**PROJECT SPECIFIC PLAN
WAC ATTAINMENT OF COLLAPSED SOIL
IN PADDY'S RUN**

**FERNALD ENVIRONMENTAL MANAGEMENT PROJECT
FERNALD, OHIO**

**20540-PSP-0001
REVISION 0**

VARIANCE / FIELD CHANGE NOTICE

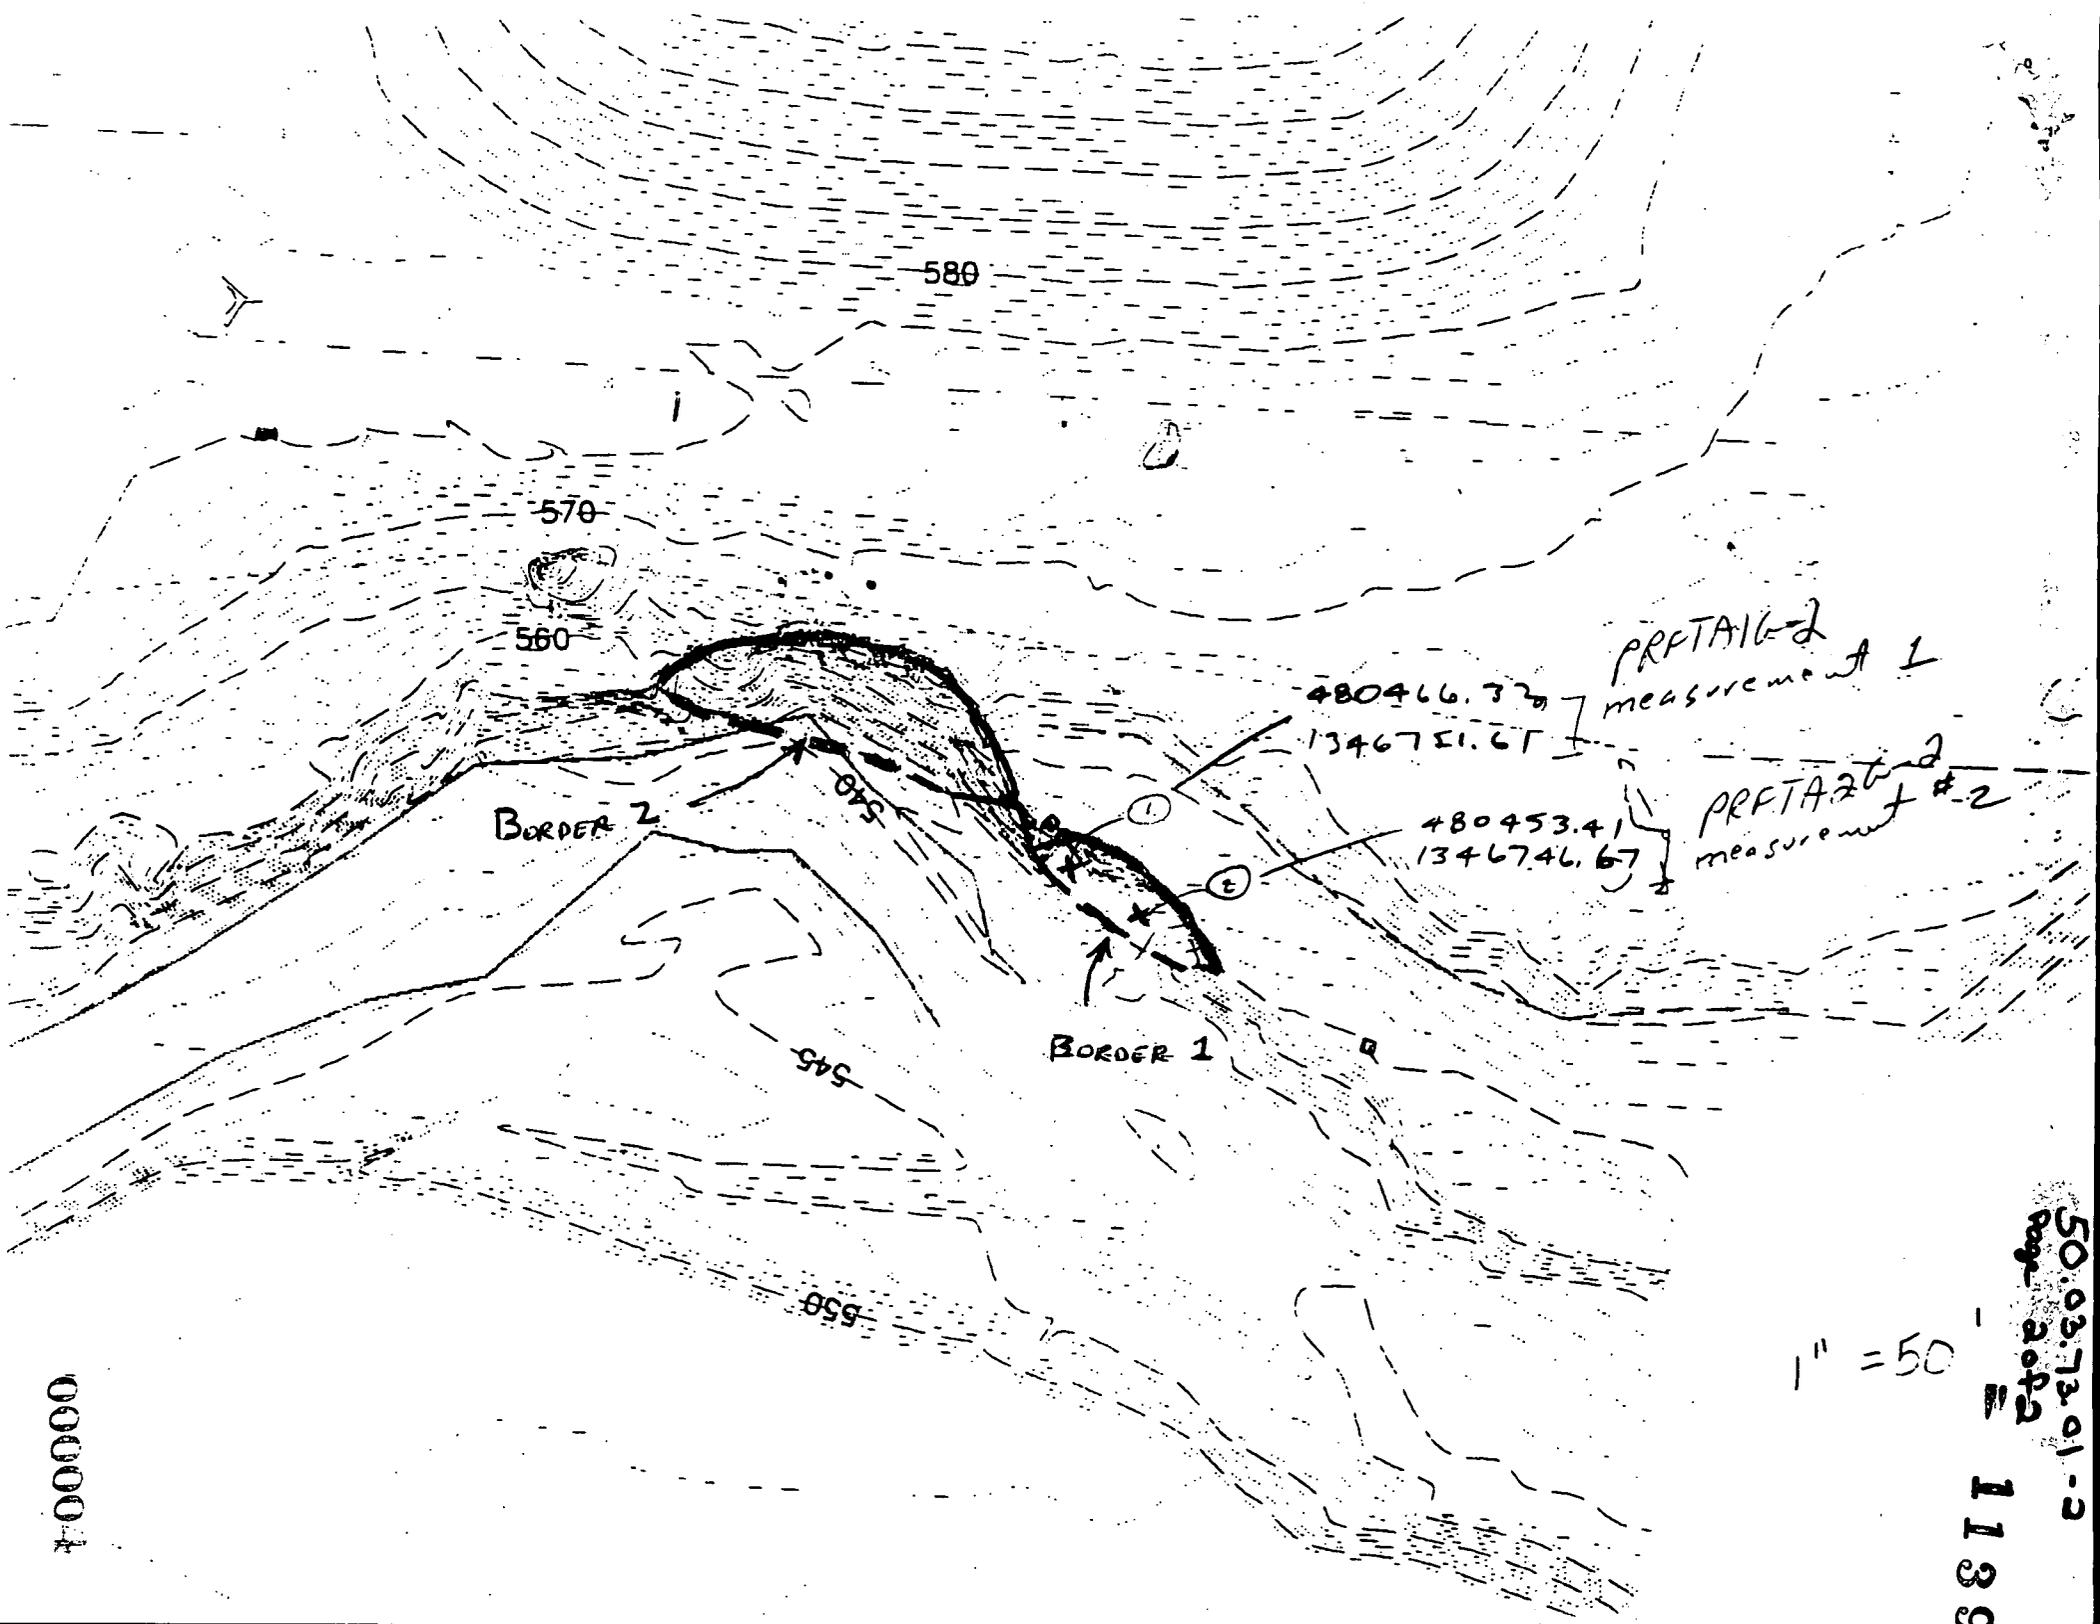
This variance/field change notice documents that additional HPGe readings were collected on 10/9/97 in segment 2 (as identified in Figure 1-1 in the PSP). The readings under this variance represent the POST-excavation HPGe readings. Measurements were collected on Detector 30716 as records 885 and 886. They were labeled as PRFTA1G-1 (Paddys Run Fallen Tree Area (1 meter - record 885) and PRFTA2G-2 (1 meter- record 886). This variance ties to Variance 50.03.73.01-1, the PRE-excavation samples and HPGe readings.

This variance/field change notice specifies the collection of HPGe gamma measurements within segment 2 as identified in Figure 1-1 in the PSP, to ensure the radium contaminated soil from beneath the tree root had been removed. Excavation occurred on 10/8/97

MAP OF SOIL COLLAPSED INTO PADDYS RUN AND RANDOM WAC SAMPLE LOCATIONS
FIGURE 1-1.

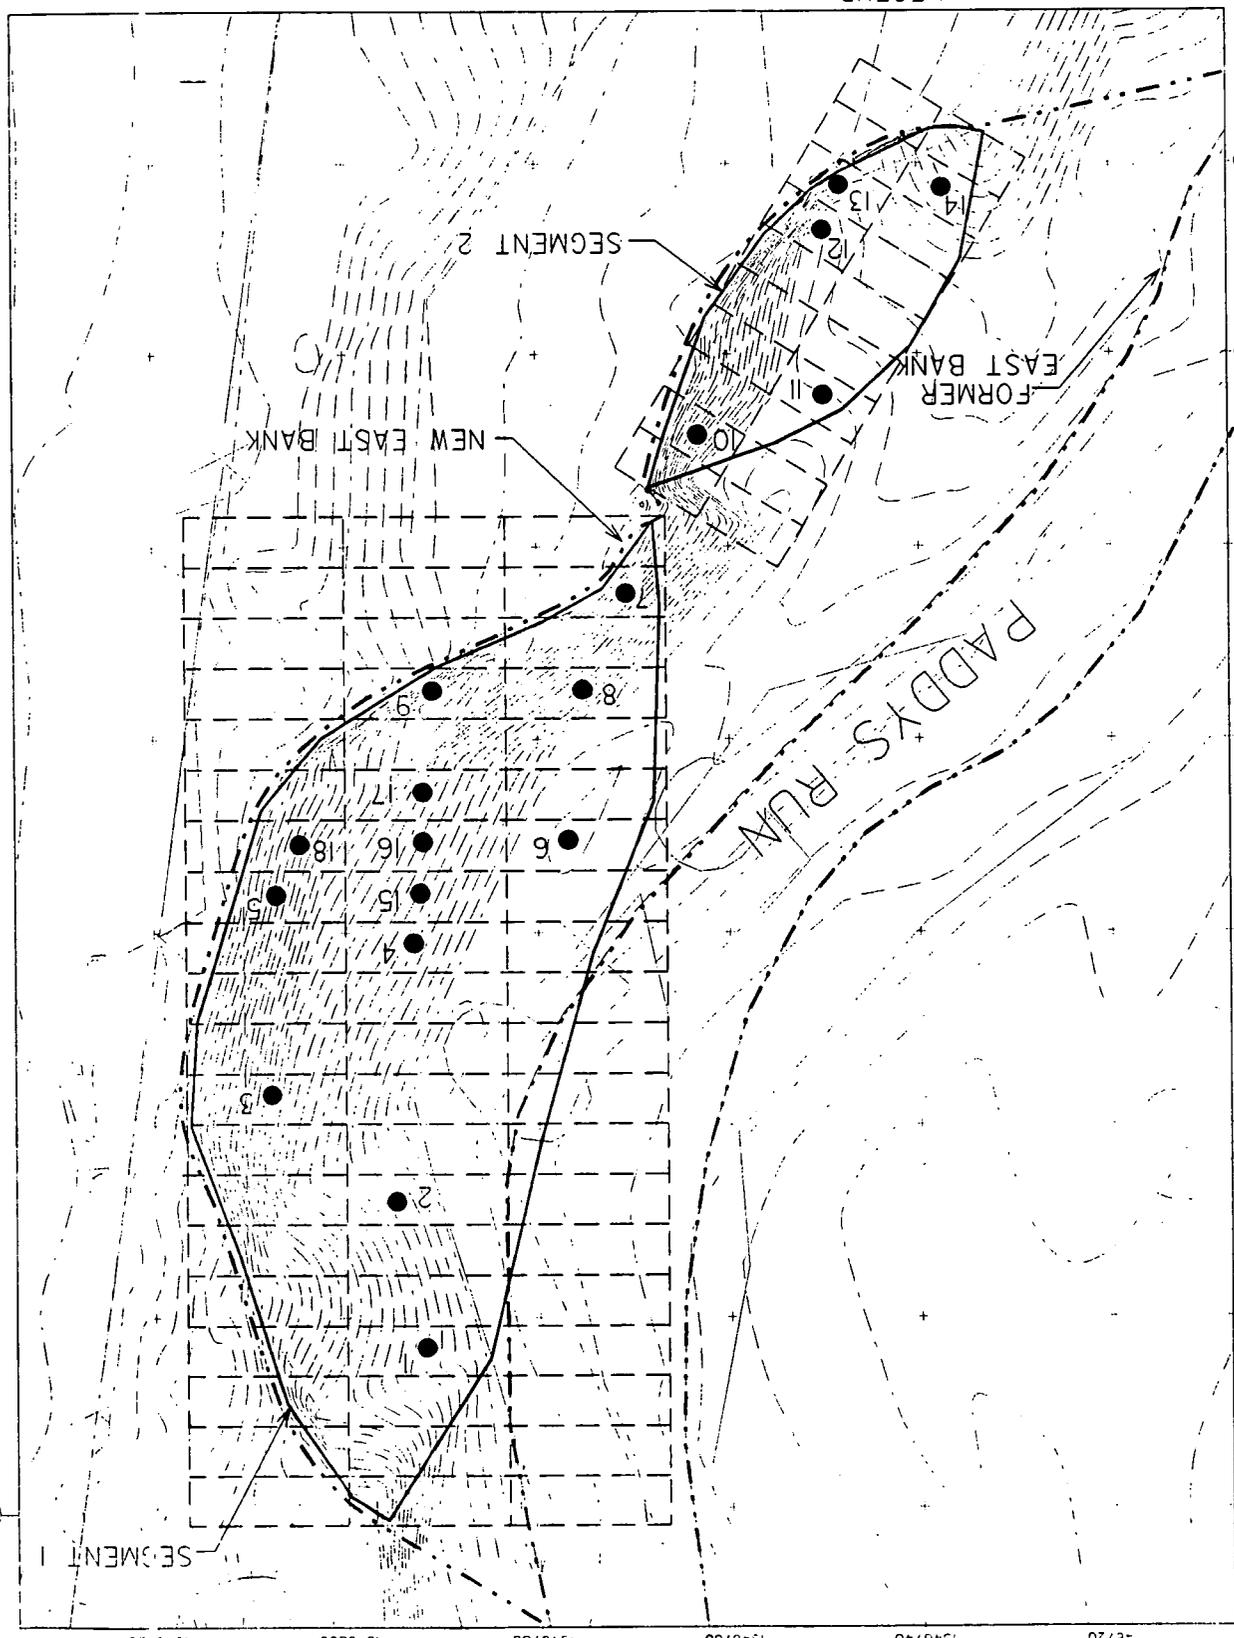
1) This variance/field change notice specifies additional sampling in the soil contamination area within segment 2 as identified in Figure 1-1 in the PSP. The soil contamination area is in the vicinity of a tree root that was removed from the soil slough area within the Paddys Run stream channel.

2) This variance/field change notice specifies the collection of HPGe gamma measurements within segment 2 as identified in Figure 1-1 in the PSP. Measurements will be collected on Detector 30716 as records 880, 881, and 882. They will be labeled as PRFTA (Paddys Run Fallen Tree Area) #1 (1 meter - record 880; one foot - record 881) and PRFTA #2 (one meter- record 882).

1. This variance/field change notice specifies a change in the soil sampling and analyses in segment 2, as identified in Figure 1-1 in the PSP.

Samples 10 through 14 will be collected for radium-226 (Segment 2) to determine if the soil in the area is below the FRL for this constituent. A TAL list will be added for radium-226, and will be titled TAL PRFR-E using GAMMA Spectroscopy (ASL B).
